NTSB No. CEN15MA290

Airbus Helicopters Service Bulletin No. AS350-67.00.64 (63 Pages)

SUBJECT: ROTOR FLIGHT CONTROLS - Double hydraulic servocontrols

"HYDR" test indication for double hydraulic servocontrols
 Corresponds to modification 074622

Figure 21

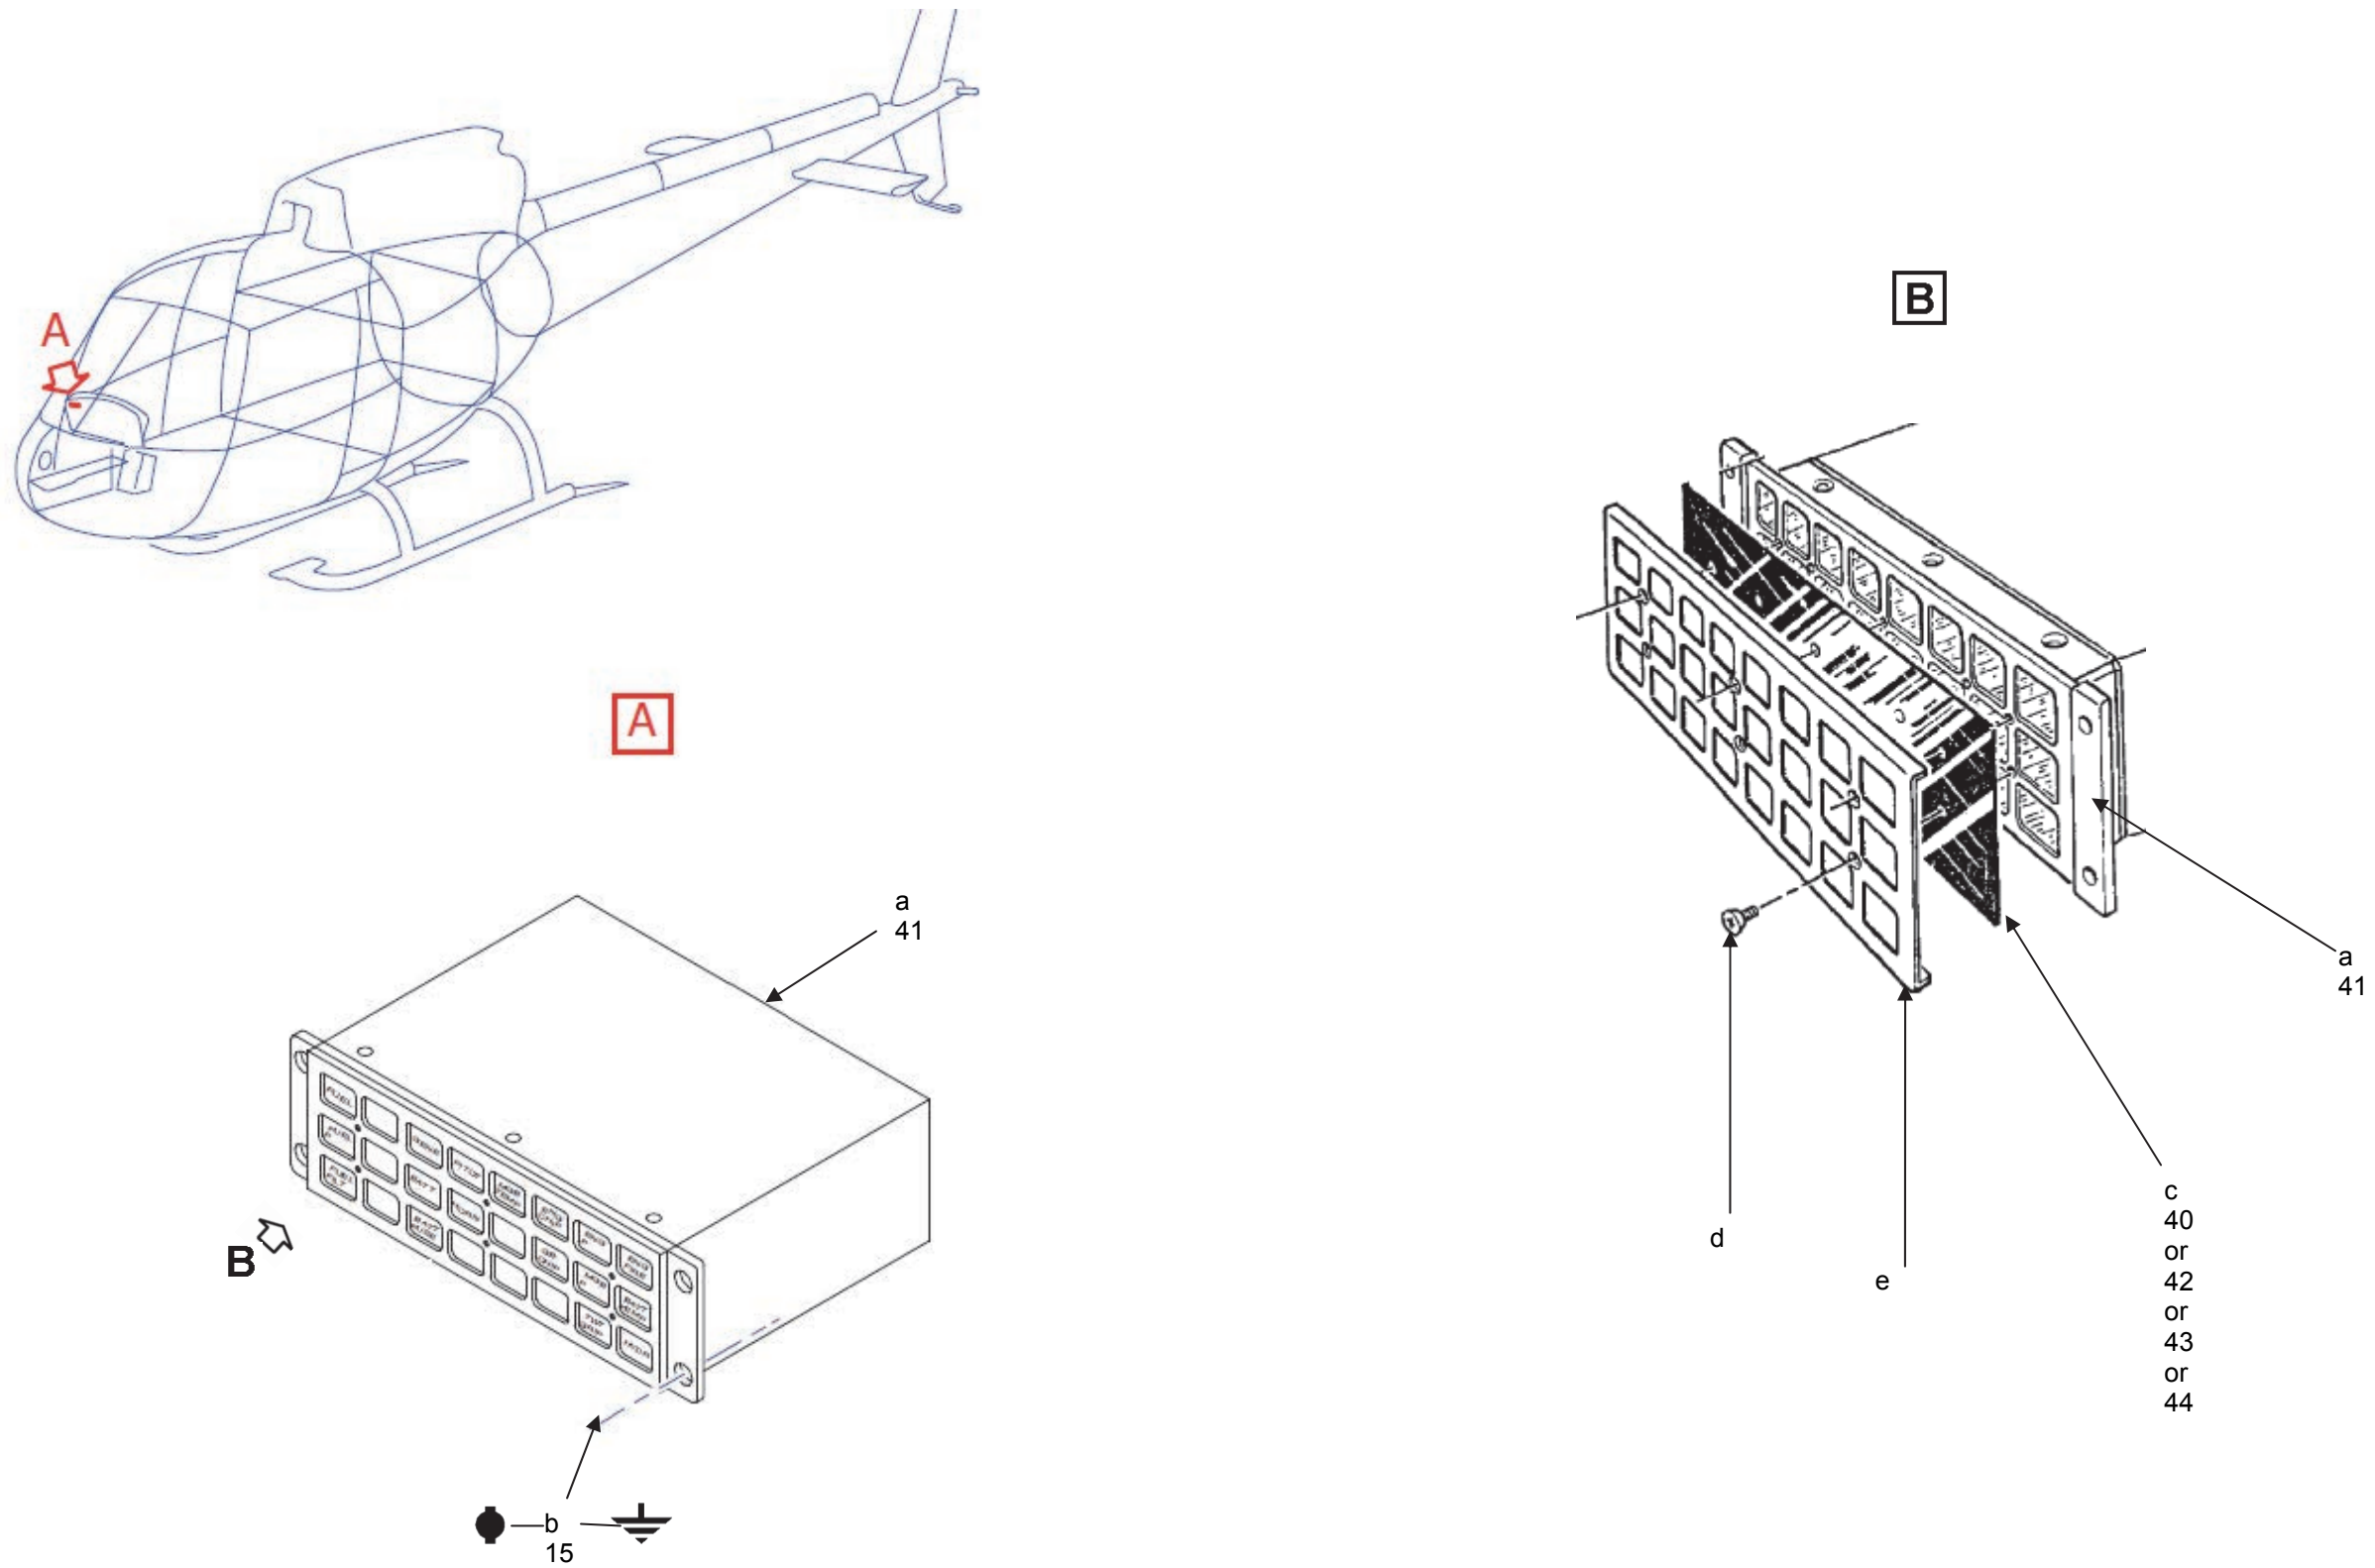
3.B.2.c. Modification of caution and warning panel

- Remove caution and warning panel assembly (a) and discard screws (b).
- Perform electrical bonding of screws (15).
- Attach new caution and warning panel (41) with screws (15).
- Tighten screws (15) to standard torque.
- Remove label (c):
 - . remove and retain screws (d),
 - . remove and retain front face (e),
 - . remove and discard label (c).
- Install label (40):
 - . install label (40) between caution and warning panel (41) and front face (e),
 - . attach front face (e) to caution and warning panel (41) with screws (d).

3.B.2.c.2. For helicopters POST MOD 074280 and PRE MOD 075606 or POST MOD 075606 or POST OP 3346 and PRE MOD 073368 or with A.P. fixed parts (Figure 21)

- Remove label (c):
 - . remove and retain screws (d),
 - . remove and retain front face (e),
 - . remove and discard label (c).
- Install label (42) or (43) or (44):
 - . install label (42) or (43) or (44) between caution and warning panel (a) and front face (e),
 - . attach front face (e) to caution and warning panel (a) with screws (d).
